ADDENDUM 3

ADDENDUM DATE: November 19, 2024

PROJECT: Onslow County Senior Services Center Renovation
4024 Richlands Highway
Jacksonville, NC 28540

ARCHITECT: Smith Sinnett Architecture, P.A.
4600 Lake Boone Trail, Suite 205
Raleigh, North Carolina 27607

DRAWN BY: JAV
CHECKED BY: SWC
ROOF PLAN

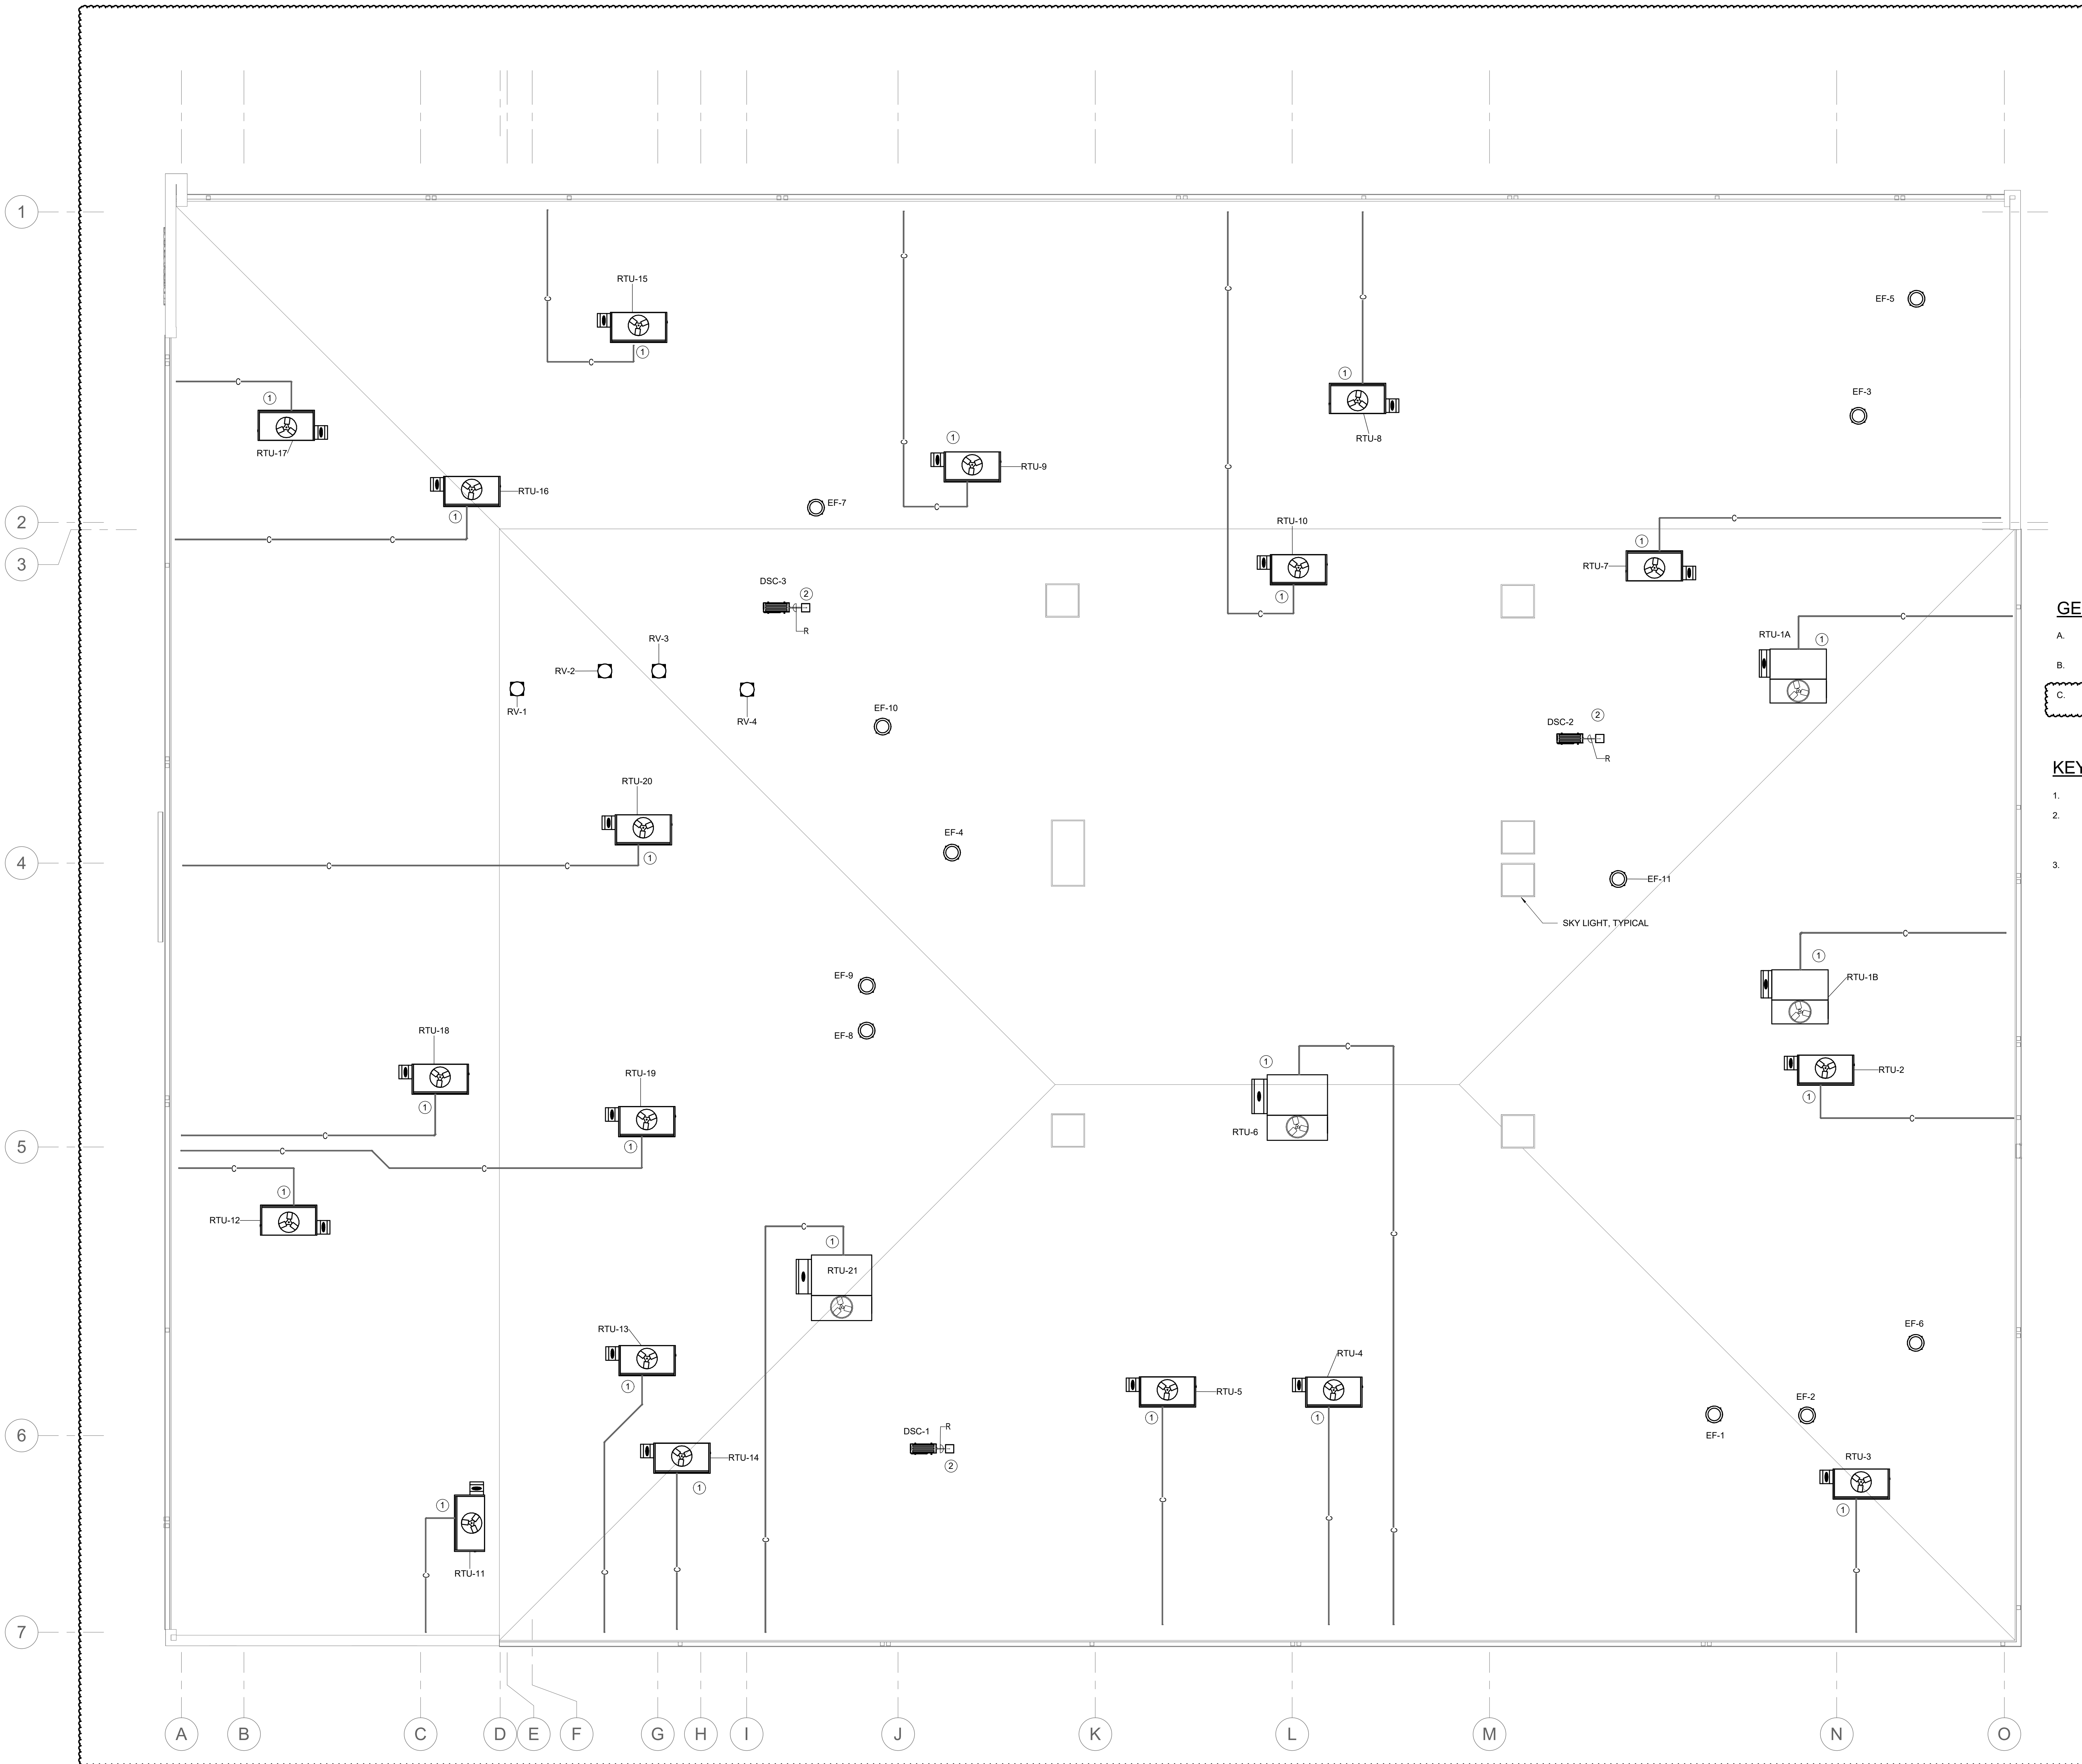
- Item 10 Contractor question: "Drawing M2-03 Keynote #1 states to extend Condensate to nearest Roof Drain. This building does not appear to have any roof drains and appears to have a gutters and downspouts installed. Per this note, do we need to pipe the condensate drain from each HVAC unit to the nearest gutter, or can the condensate spill on the roof and it then drain to the gutters via the pitch of the roof?"

Response: Pipe condensate individually from each unit to nearest gutter. Refer to M2-03 attached to this addendum.
- Item 11 Contractor question: "If the condensate drain must be piped from the HVAC roof top unit to the gutters, can the Condensate drain be manifolded together from multiple units and then piped to the gutter system? Or will they be required to be piped individually?"

- Item 63 Sheet M2-03: REPLACE the sheet in its entirety with the attached sheet M2-03.
Note the following revisions:
- Pipe condensate individually from each unit to nearest gutter.

1. Drawing M2-03
 - a. Clarified condensate piping on roof.

Response: No, the condensate lines shall not be manifolded together from multiple units. Pipe condensate individually from each unit to nearest gutter. Refer to M2-03 attached to this addendum.

8 CAMERA SYSTEM RISER
NOT TO SCALE

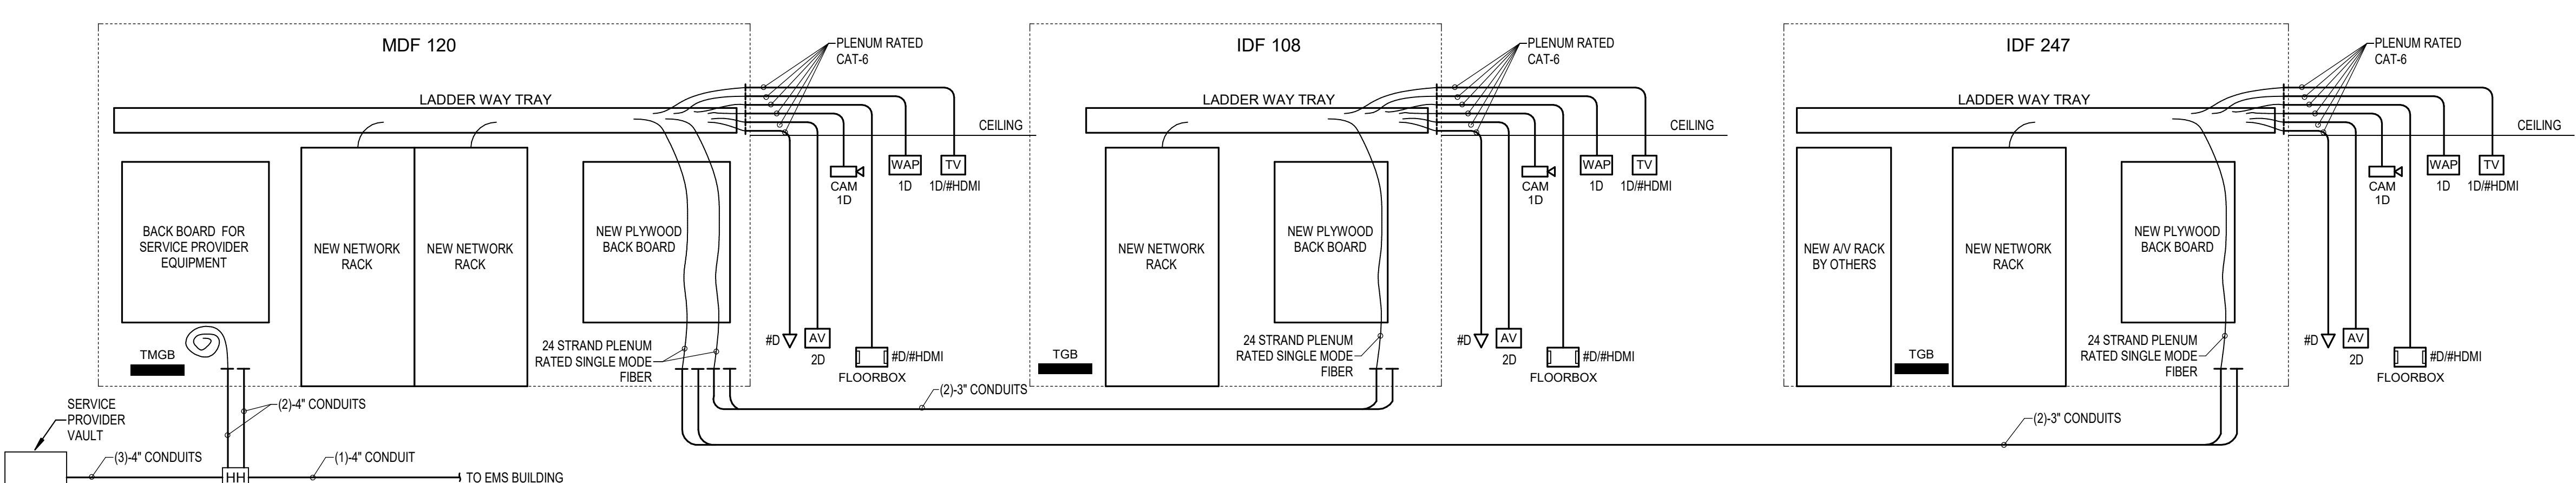
1. Drawing E0-01
 - a. Clarified: Security Symbols WA, LR, SEC and KP – All conduit and outlet boxes by EC, wiring and devices by owner/others.
2. Drawing E0-03
 - a. Deleted Security Intrusion Detection Riser.
3. Drawing E2-01
 - b. Clarified: Power outlets and Data outlets network for flat panels, CPU's and Scanners associated with Receptions 102 and Lobby 101.
 - c. Added: Keynotes 25 and 26.
2. Drawing E3-01
 - a. Added: General Note I and Keynote 7.
 - b. Revised: HDMI connections at rooms 104E and 115.
 - c. Clarified: Network connections at rooms 101 and 102 between CPU's and monitors/scanners.
 - d. Revised: HDMI Cable drop Schedule.
3. Drawing E3-02
 - a. Delete: HDMI cabling at Training Rooms 222 and 223.
 - b. Revised: HDMI Cable drop Schedule.

1 POWER PLAN - AREA A
1/8" = 1'-0"

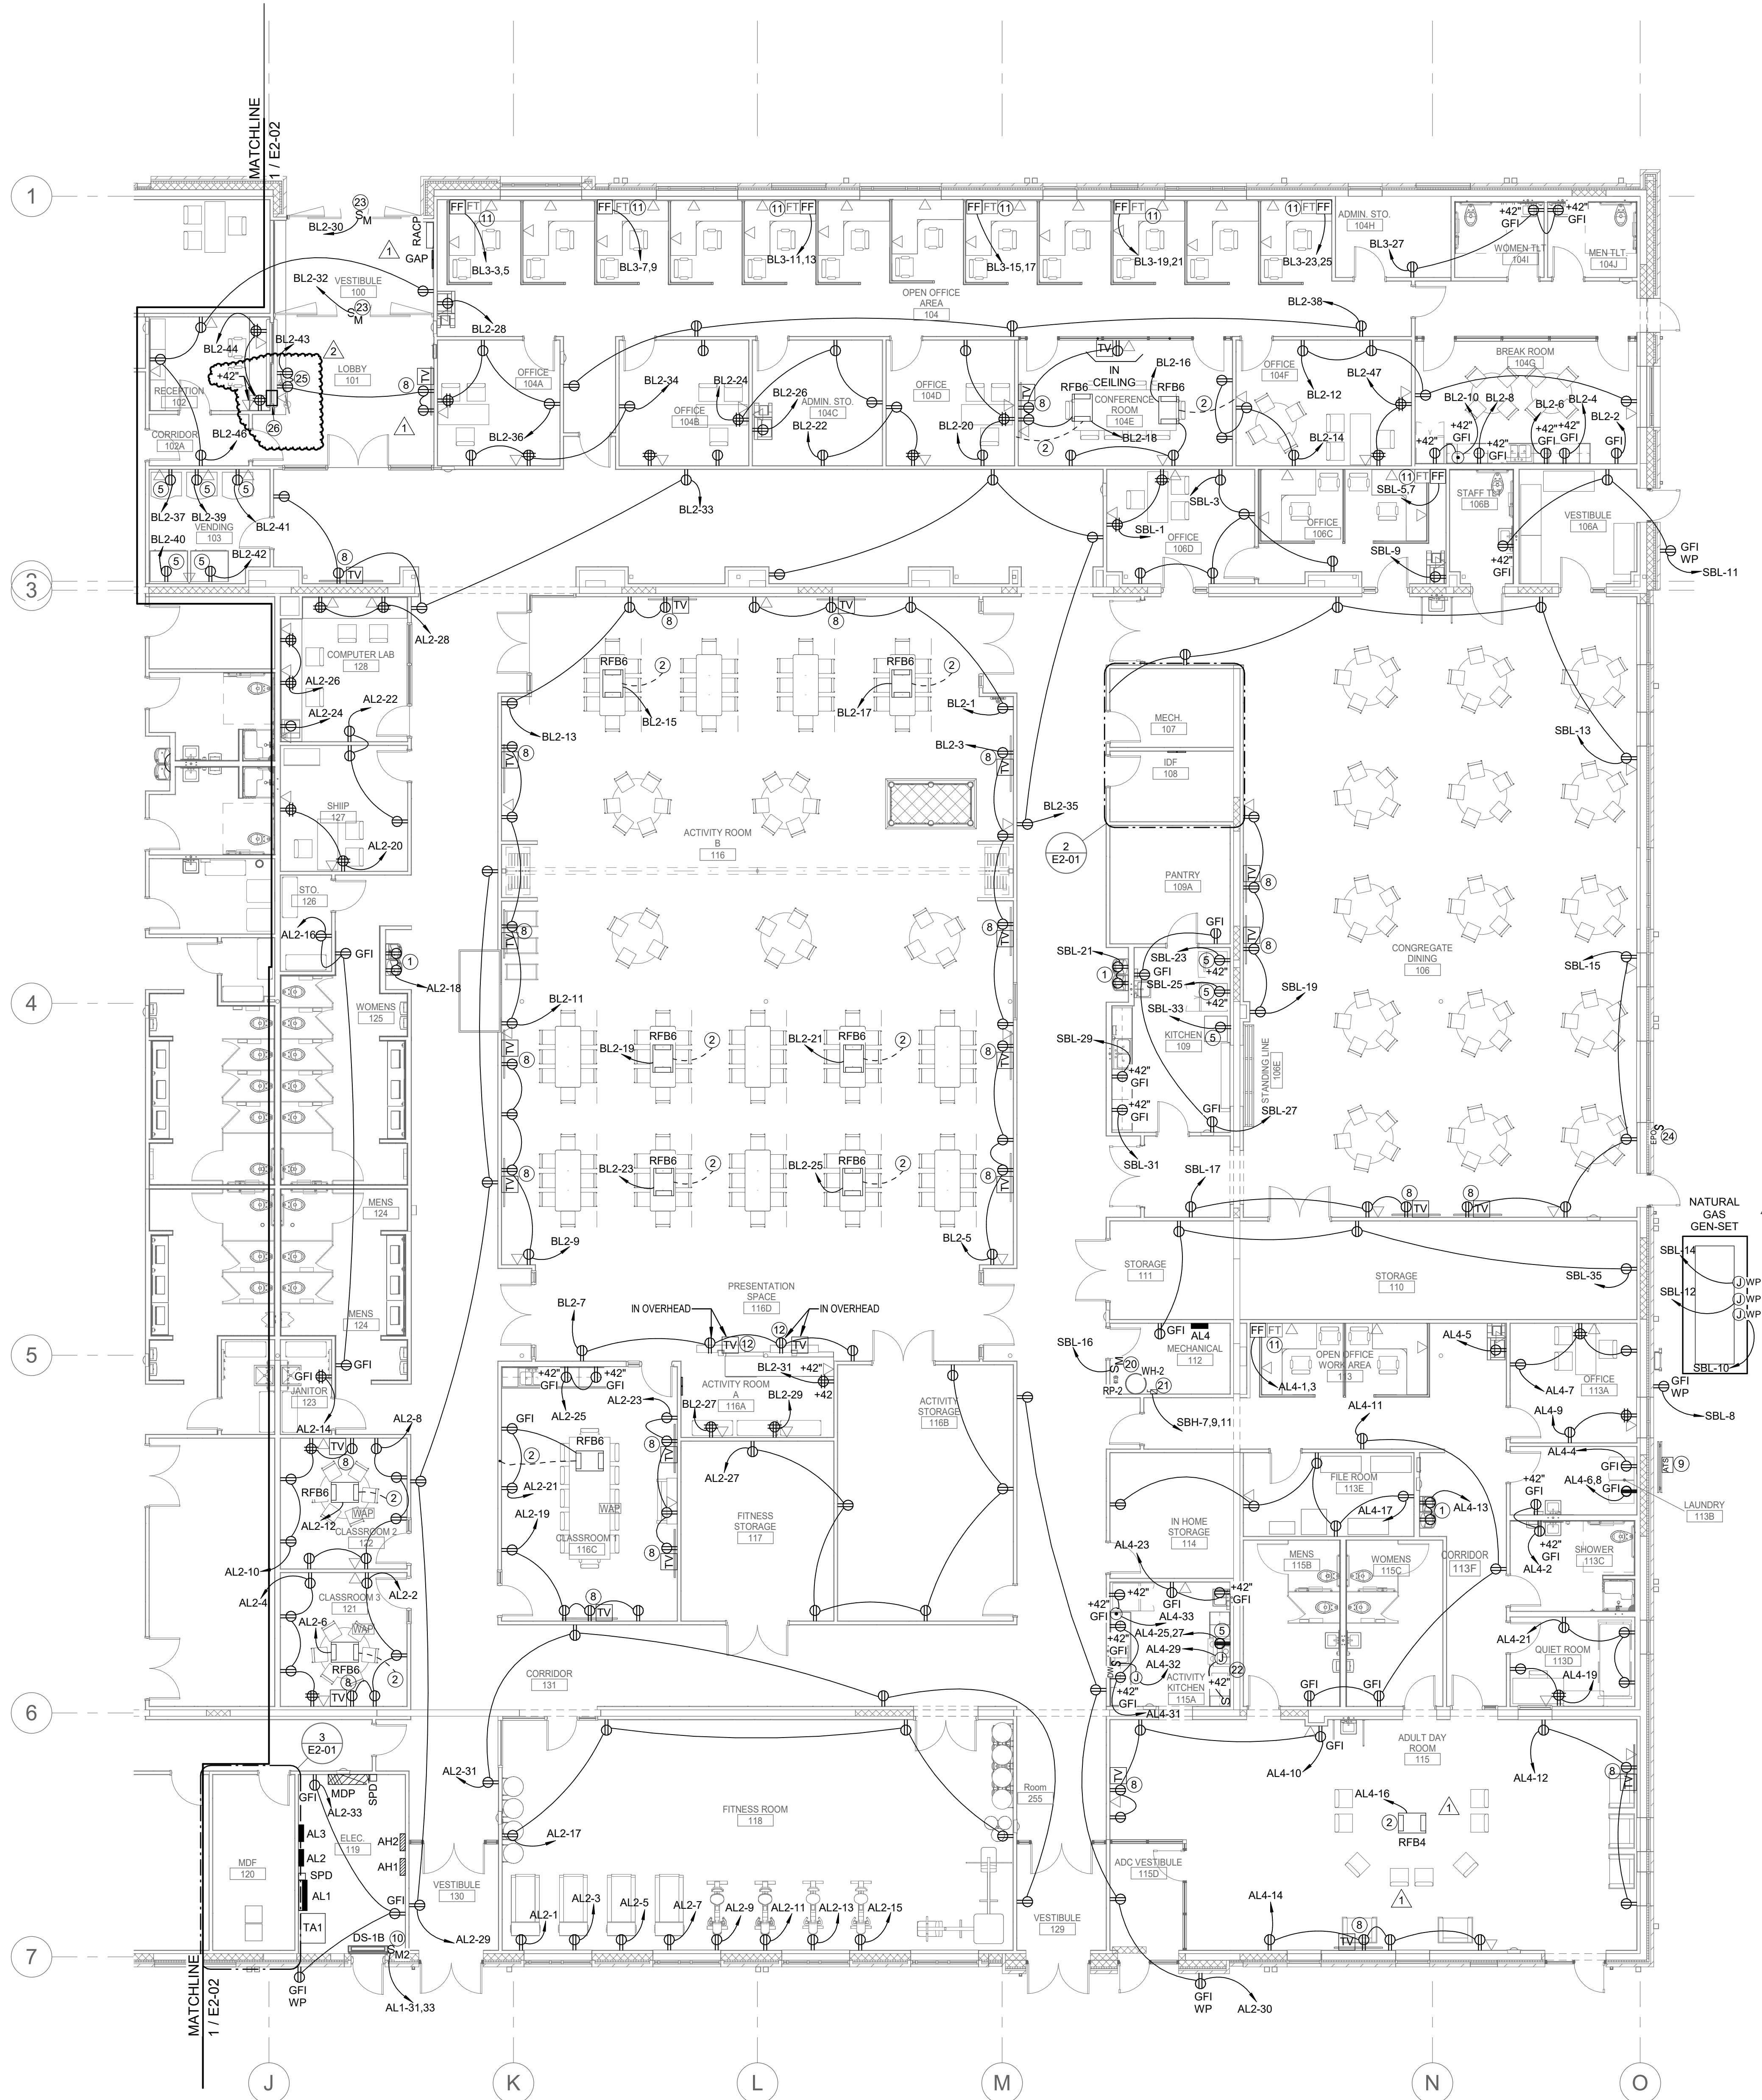
- Item 66 Sheet E2-01: REPLACE the sheet in its entirety with the attached sheet E2-01.
Note the following revisions:
- Clarified: Power outlets and Data outlets network for flat panels, CPU's and Scanners associated with Receptions 102 and Lobby 101.
 - Added: Keynotes 25 and 26.
- Item 67 Sheet E3-01: REPLACE the sheet in its entirety with the attached sheet E3-01.
Note the following revisions:
- Added: General Note I and Keynote 7.
 - Revised: HDMI connections at rooms 104E and 115.
 - Clarified: Network connections at rooms 101 and 102 between CPU's and monitors/scanners.
 - Revised: HDMI Cable drop Schedule.
- Item 68 Sheet E3-02: REPLACE the sheet in its entirety with the attached sheet E3-02.
Note the following revisions:
- Delete: HDMI cabling at Training Rooms 222 and 223
 - Revised: HDMI Cable drop Schedule.

26. PROVIDE CABLE PASS THROUGH BETWEEN RECEPTIONS 102 CPUS AND LOBBY 101 FLAT PANEL SCANNERS FOR (4) PLENUM RATED CAT-6 CABLES. COORDINATE FINAL LOCATIONS WITH ARCHITECT PRIOR TO ROUGH-IN.
